DRAFT DECISION
Australian Gas Networks
Access Arrangement
2016 to 2021

Attachment 6 – Capital
expenditure

November 2015

Figure 6.3 AGN proposed CI/UPS and HDPE mains replacement volumes

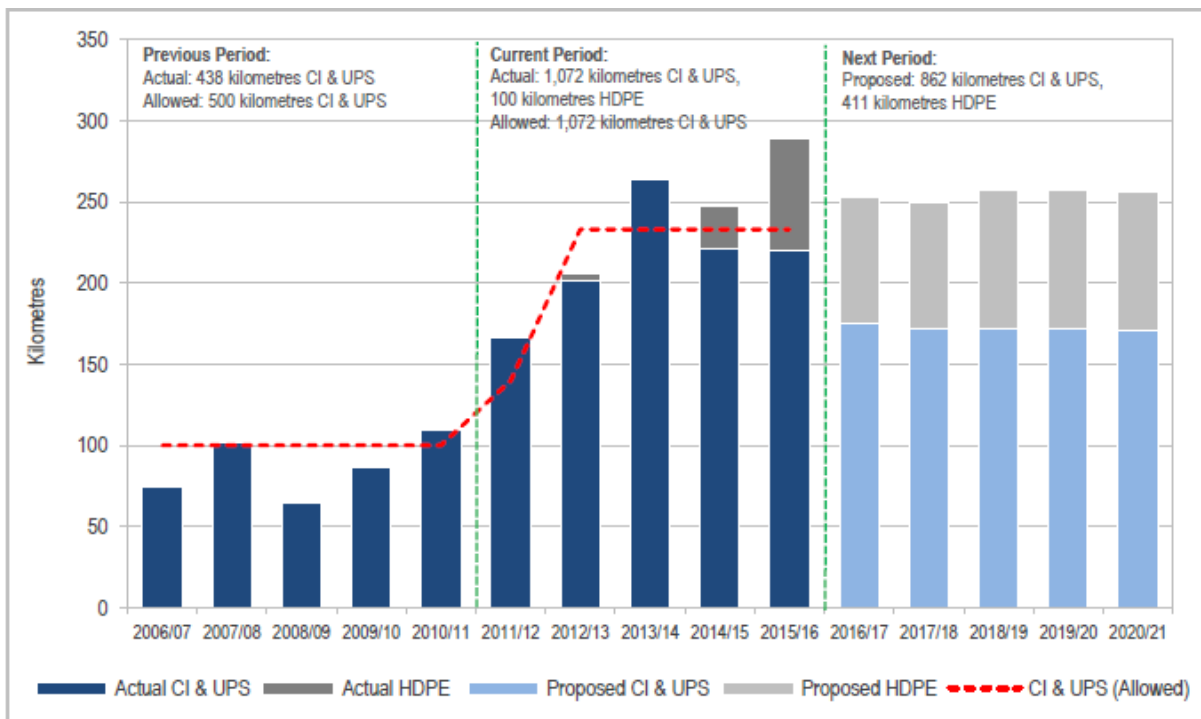
The proposed capex amount of \$369.9 million involves replacing 1273 km of mains. The proposed kilometres of mains to be replaced compared to the current and previous periods are set out in Figure 6.3.

Over the 2016–21 access arrangement period, AGN proposed to replace the remaining 862 km⁷² of CI and UPS mains in the network, and to commence a new HDPE program replacing 411 km of mains.⁷³ The proposed kilometres of mains replacement is about 8 per cent higher than the 1,172 km of mains that AGN expected to replace in the 2010–15 access arrangement period. While most of the replacement relates to CI and UPS mains, approximately 100 km of HDPE mains was also replaced in the latter half of the 2010–15 access arrangement period. This is illustrated in Figure 6.3.

We have not adopted AGN’s proposed mains replacement expenditure and have therefore determined an alternative estimate. Our alternative estimate does not identify the specific allocation of capex across the three types of mains pipe replaced (CI, UPS or HDPE). Since we have not been provided with a rigorous risk assessment, we have used the limited information and data before us to derive an alternative estimate of the kilometre of main pipes we consider would be more efficient than what AGN has proposed to replace during the 2016–21 access arrangement period.

Since we do not have the information to undertake a rigorous risk assessment, we have based our alternative estimate on the kilometre of main pipes we consider would be efficient to replace during the 2016–21 access arrangement period. To derive our alternative capex estimate, we have reduced AGN’s proposed capex for mains replacement by our percentage reduction in total kilometres. This approach means we have applied AGN’s unit rates across all categories of mains replacement and our reduction reflects our view regarding prudent and efficient volumes of mains replacement.
